| <u>Technical Specification Page No.</u> | <u>Technical Specification Section</u> | <u>Description of Change</u> | <u>Reason for Change</u> |
| B3/4 2-7 | Fig. B3/4.2.3-1 | Replace the current operating map with a new operating map. | MEOD |
| B3/4 2-8 | Fig. B3/4.2.3-2 (new) | Add an operating map for single recirculation loop operation. | Clarification |
| B3/4 6-5 | B3/4.6.2.5 | Revise the value for drywell peak calculated pressure from 18.9 psig to 19.7 psig. | MEOD |

Bases Figure B 3/4.2.3-1 Reactor Operating Map for Two Recirculation Loop Operation

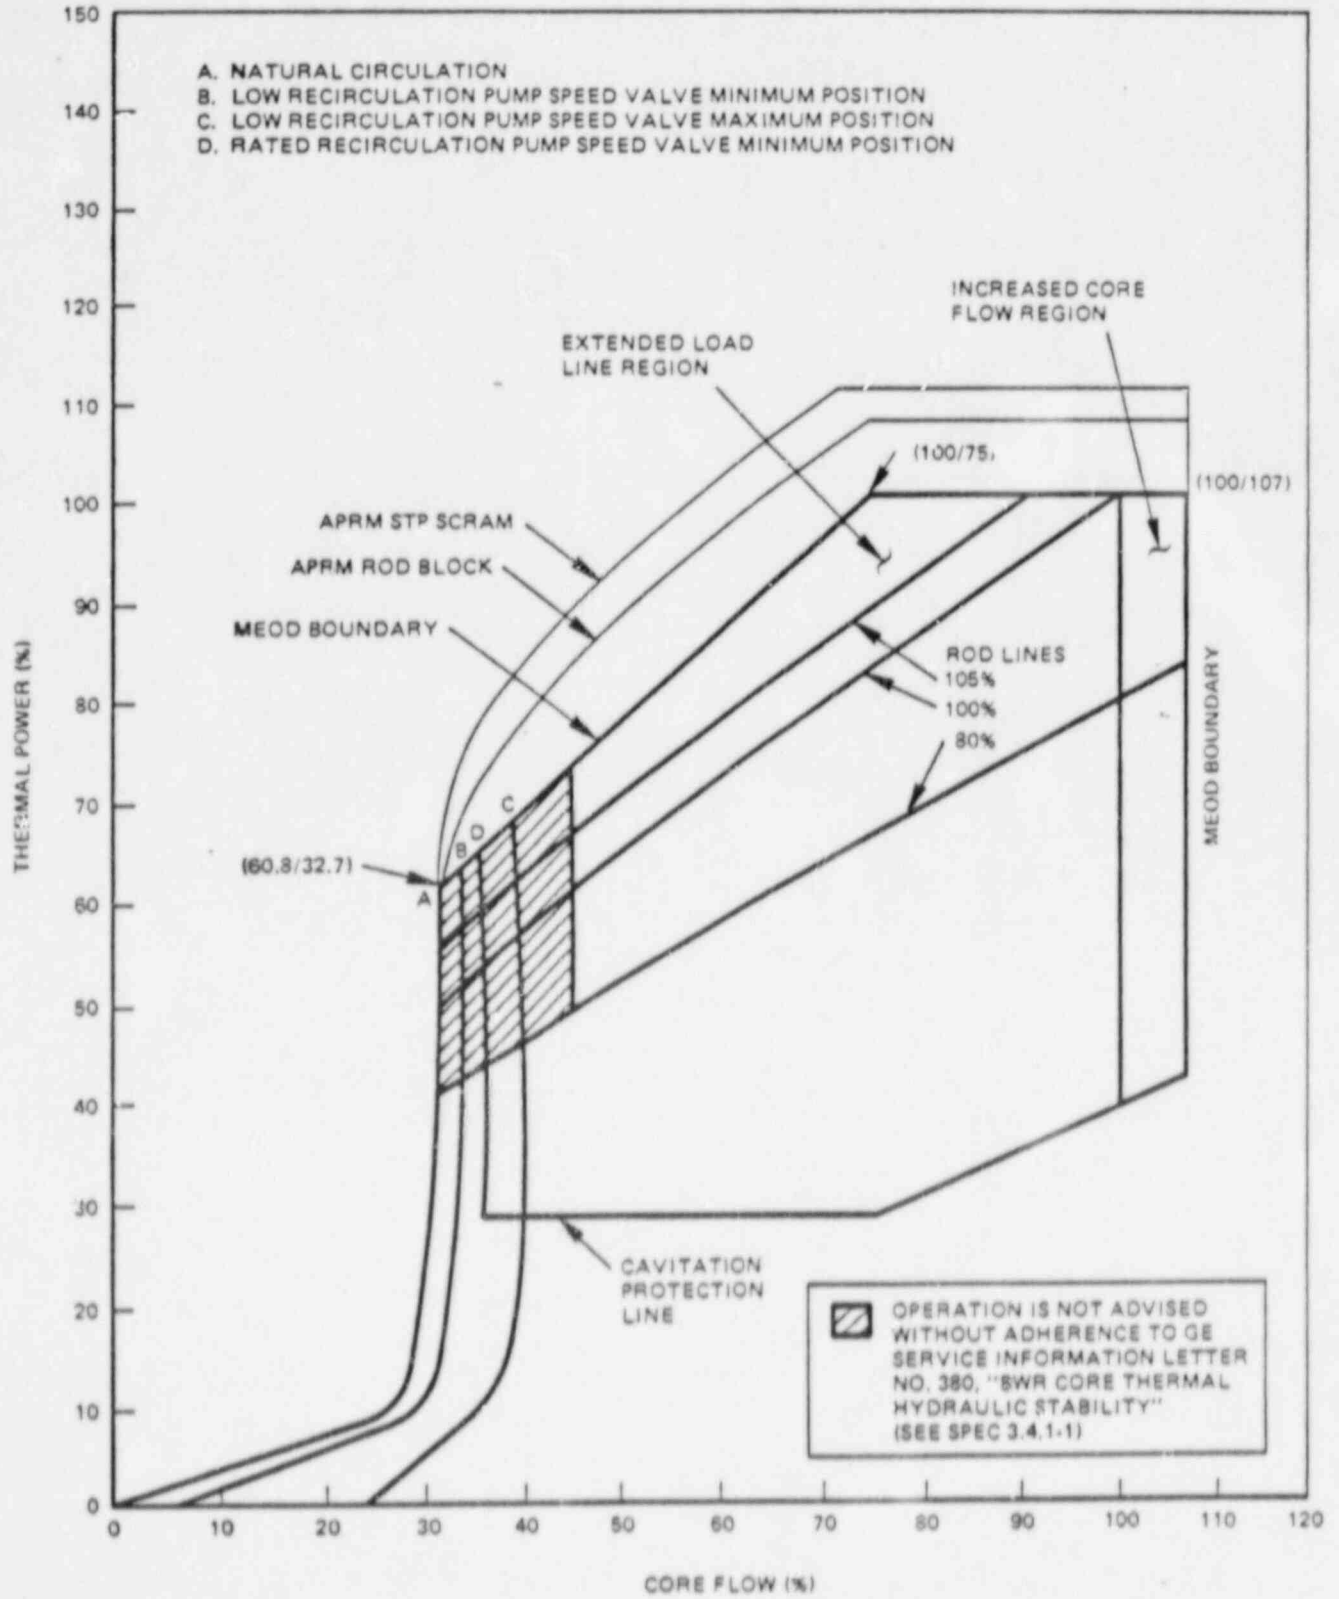
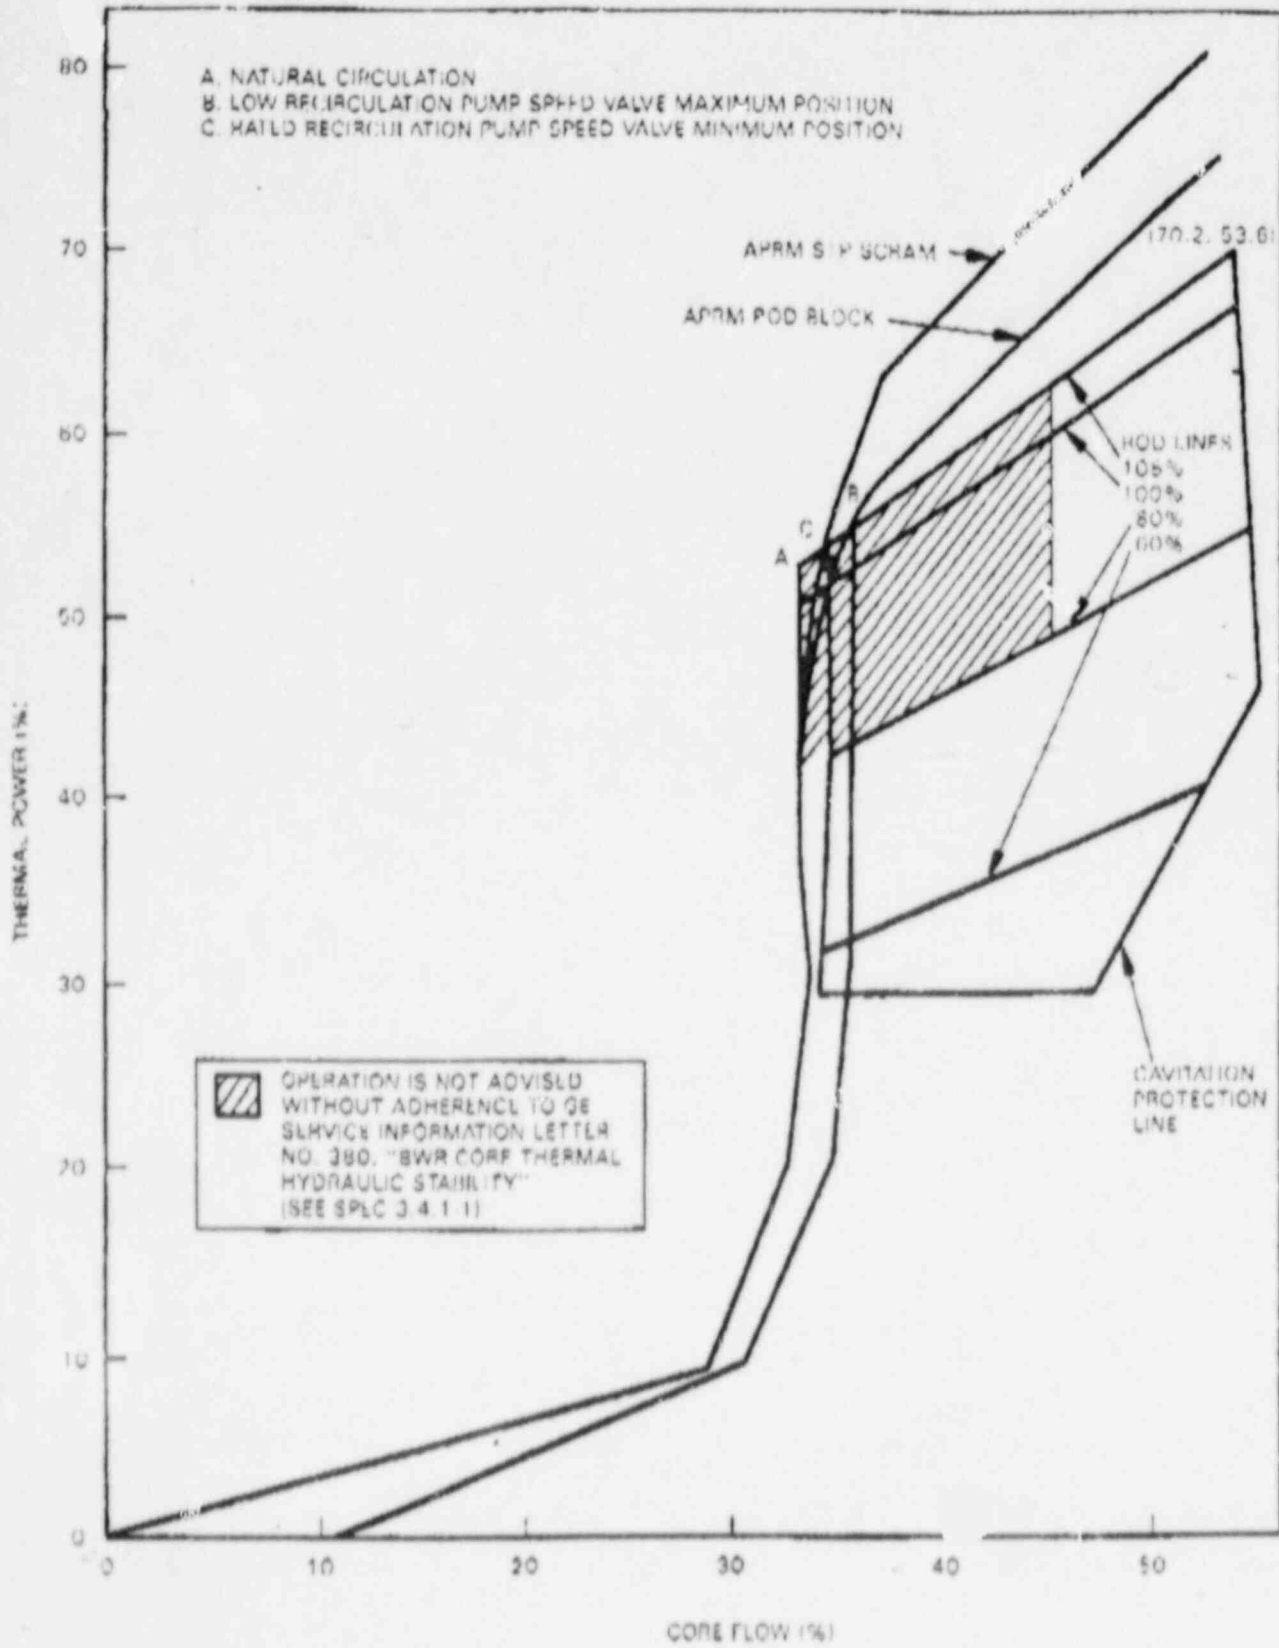
Replace with Figure B 3/4.2.3-1 Attached.

Technical Specification Bases Figure B 3/4.2.3-1: This change revises the CPS operating map. The map is being revised to show the boundary of operation allowed by the MEOD.
